**STAFF RECOMMENDATION**

**1725 Linden Avenue**

**Application:** New Construction—Addition

**Description of Project:** Application is to construct a rear addition that contains a garage at basement level. The addition will attach to an existing addition.

1 Site Plan  
 Scale: 1/16" = 1'-0"

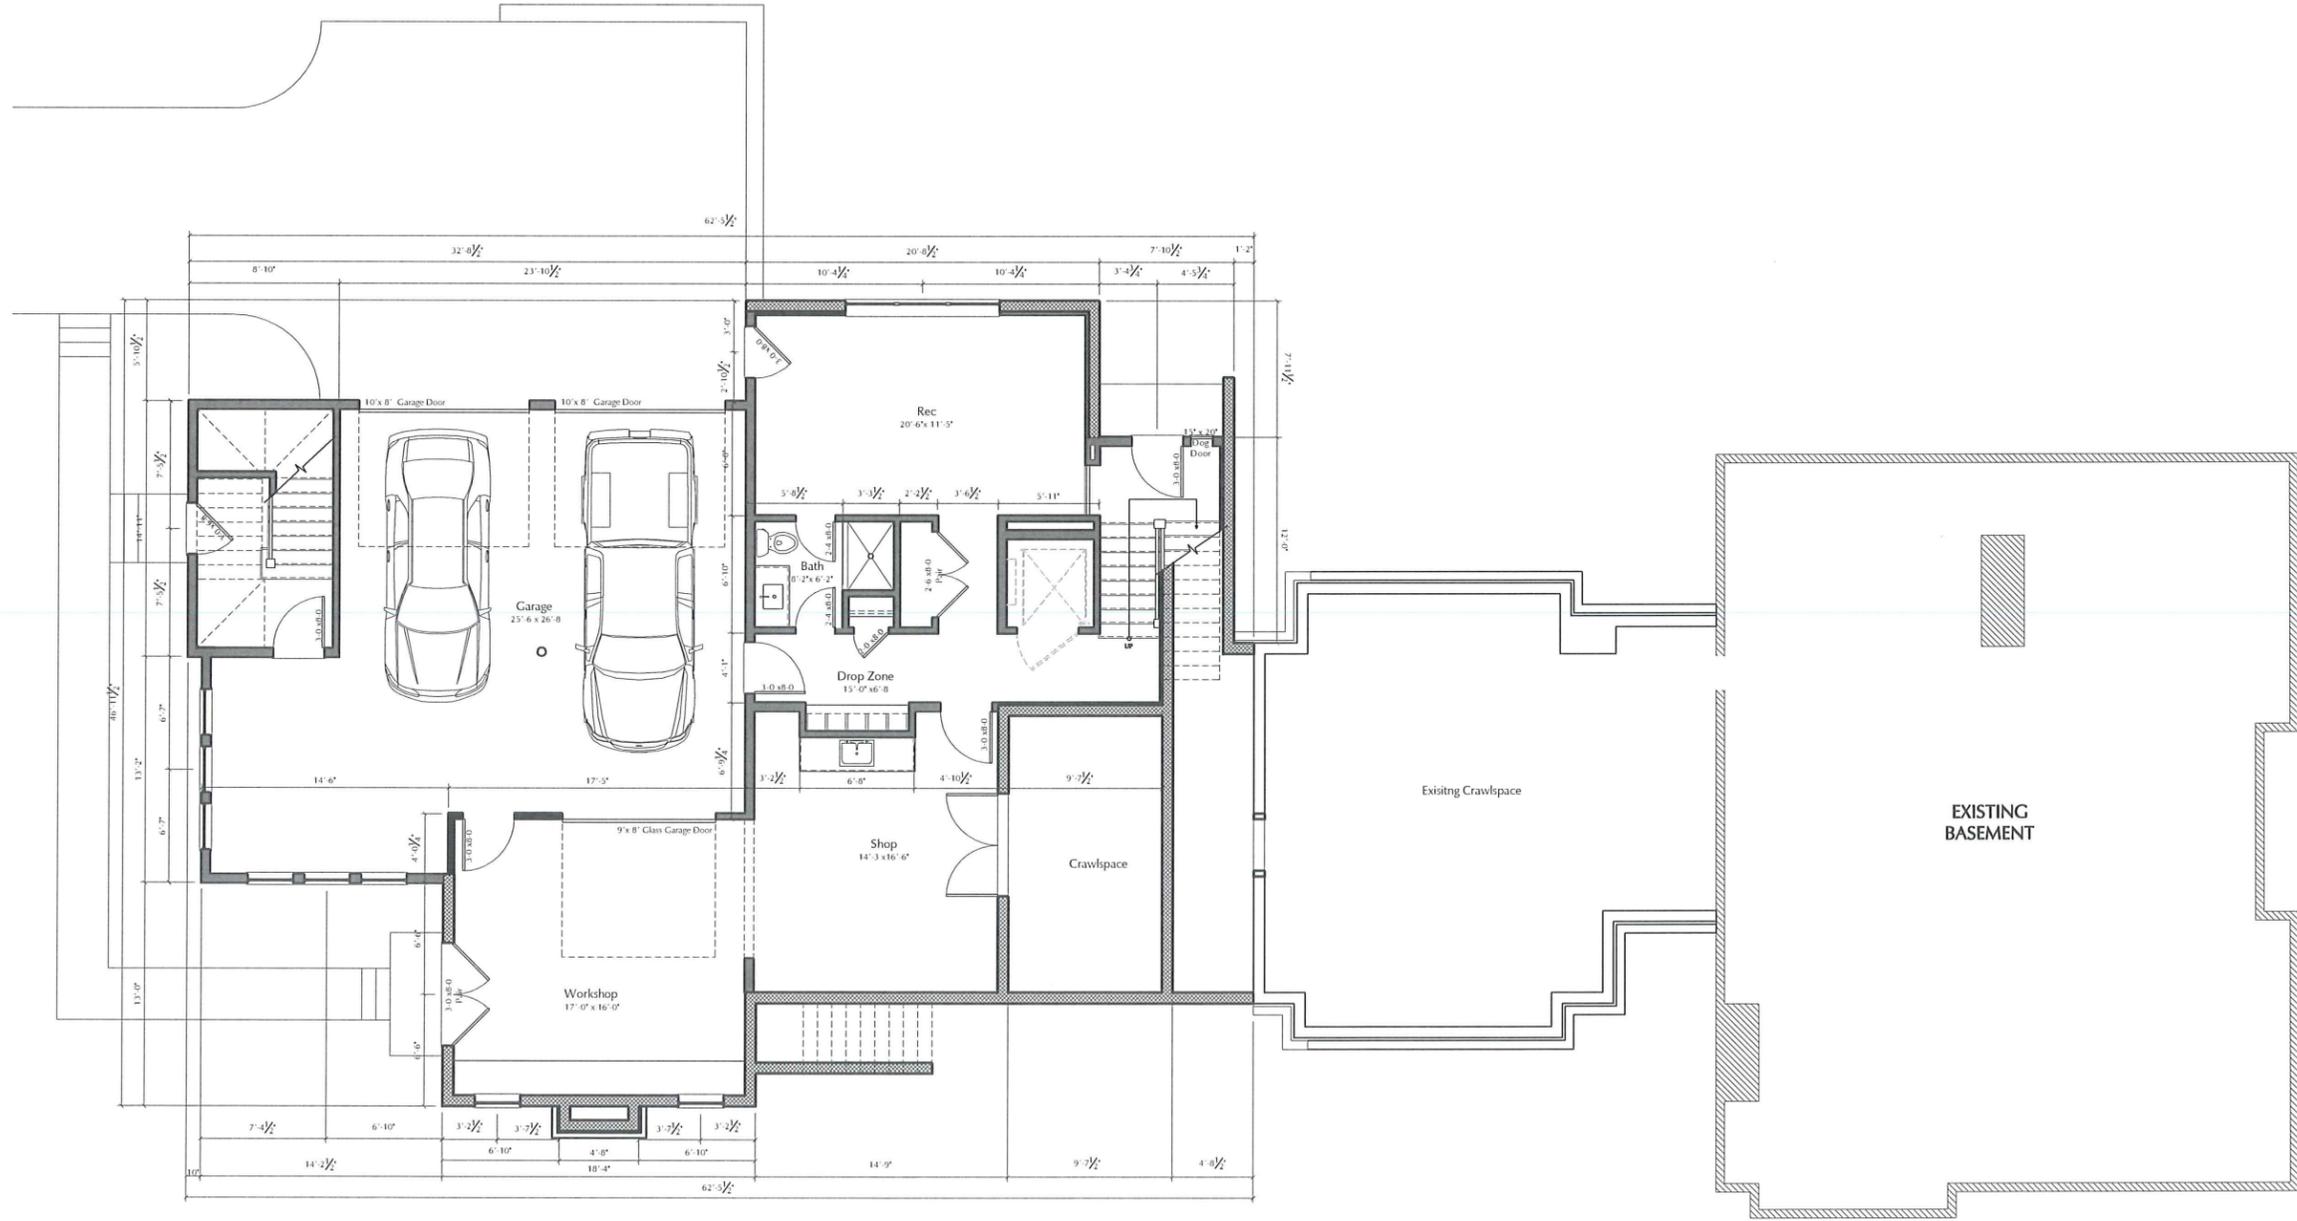
Setback & Rhythm of Spacing: The proposed addition meets all base zoning setbacks. It is a minimum of eighteen feet from the right side property line, and fifty-eight feet (58’) from the left side property line. It is twenty-two feet (22’) from the rear property line. The wider portion of the addition will not affect the rhythm of spacing of houses along Linden Avenue because of the width of the lot. Staff finds that the addition’s setbacks and rhythm of spacing meet Sections II.B.1.c. and II.B.2. of the design guidelines.

Appurtenances & Utilities: No changes to the site’s appurtenances were indicated on the drawings. The location of the HVAC and other utilities was also not noted. Staff recommends that the HVAC be located on the rear façade, or on a side façade beyond the midpoint of the house in order to meet Section II.B.1.h. of the design guidelines.

1. Staff approve the final details, dimensions and materials of windows and doors prior to purchase and installation;
2. Staff approve the roof shingle color and texture;
3. Staff approve a stone sample; and,
4. The HVAC be located behind the house or on either side, beyond the mid-point of the house.

# Roof Plan

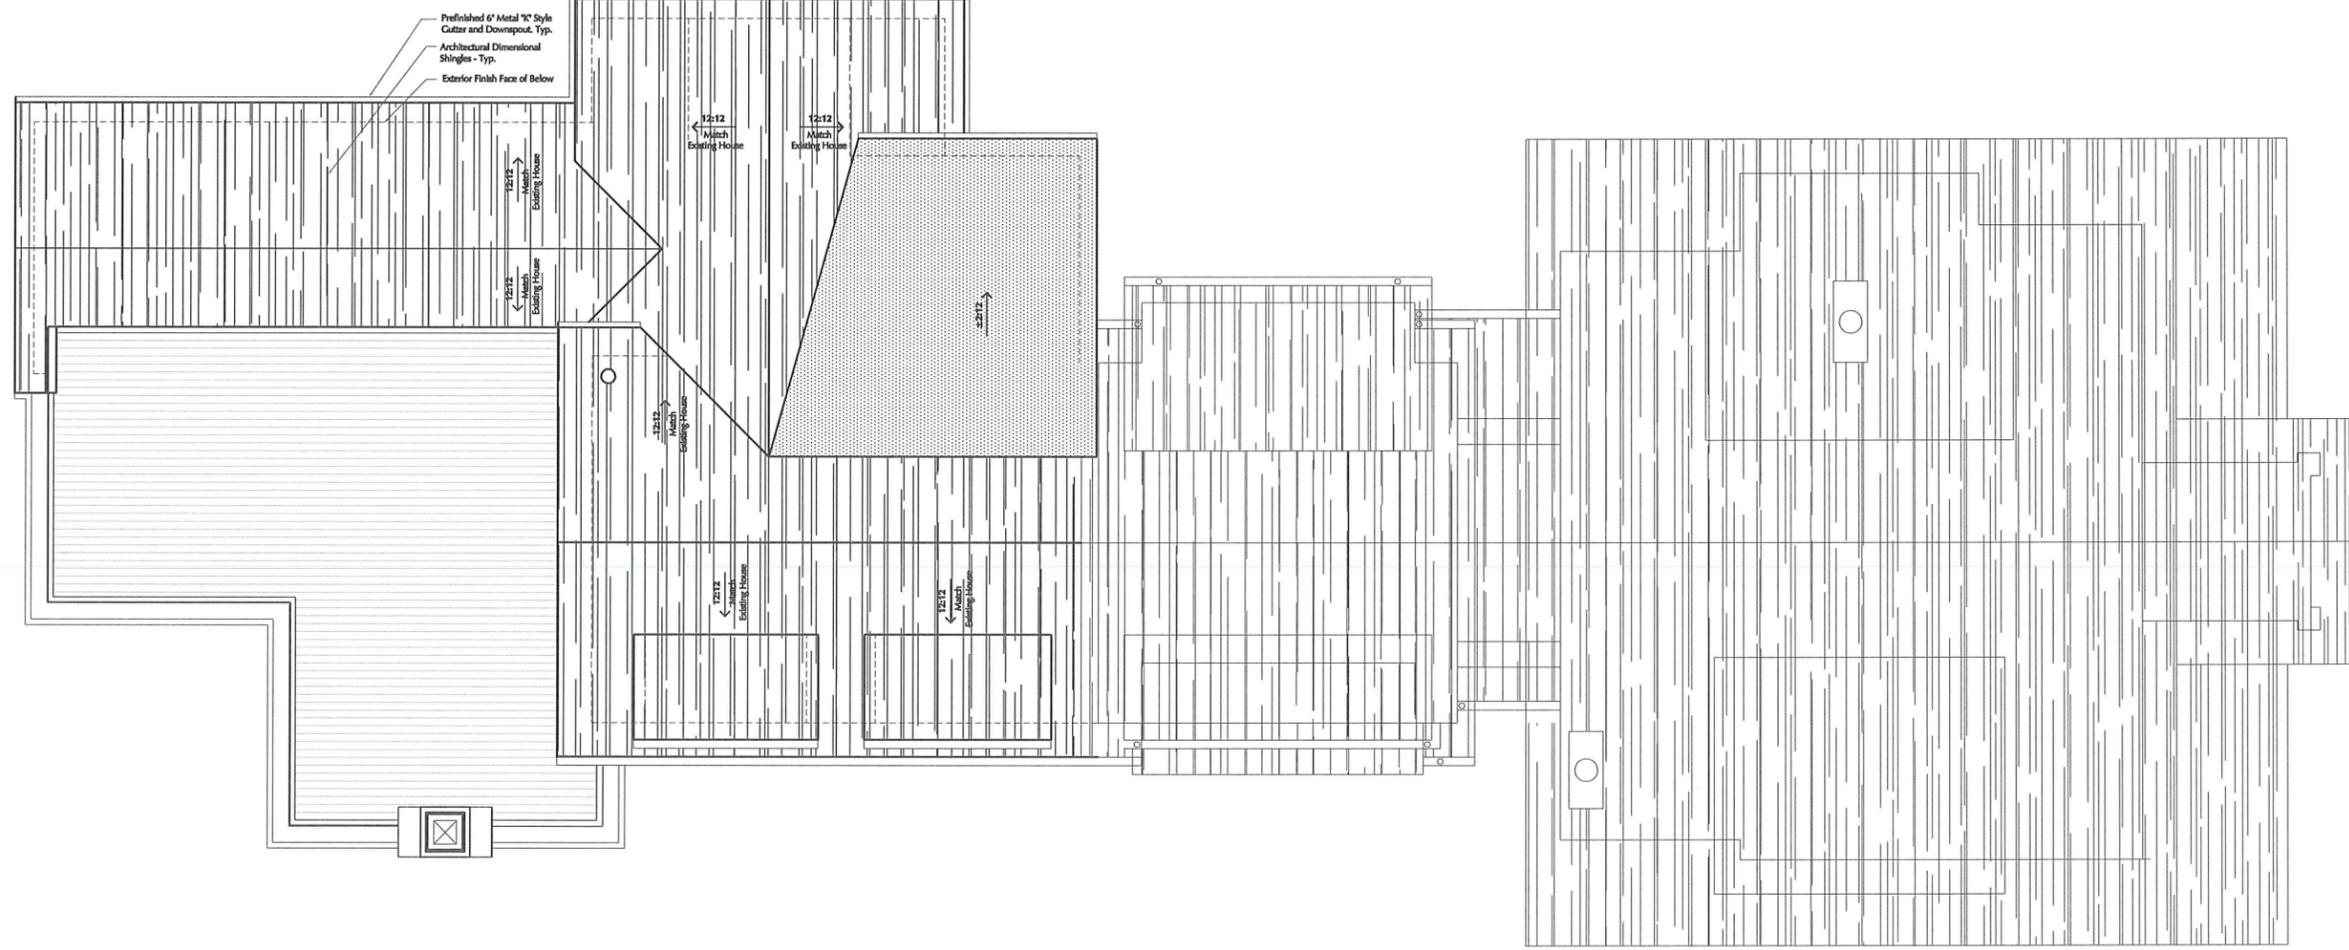
Roof form: The proposed addition will have various gable forms with a slope of 12/12, which staff finds to be compatible with the historic house’s roof form. The rear porch will have a flat roof form to allow for a deck; staff finds this to be appropriate because it is situated so far back on the lot and because this roof form is significantly lower in height than the historic house.

The left façade contains wall dormers, which are typically discouraged in new construction. Staff finds these wall dormers to be acceptable, in this instance, for two reasons. One, the wall dormers are located over seventy feet (70’) from the front of the house and over one hundred and fifteen feet (115’) back from the public view from Linden Avenue. In addition, they are inset approximately twelve feet (12’) from the back wall of the house, helping to reduce their visibility.
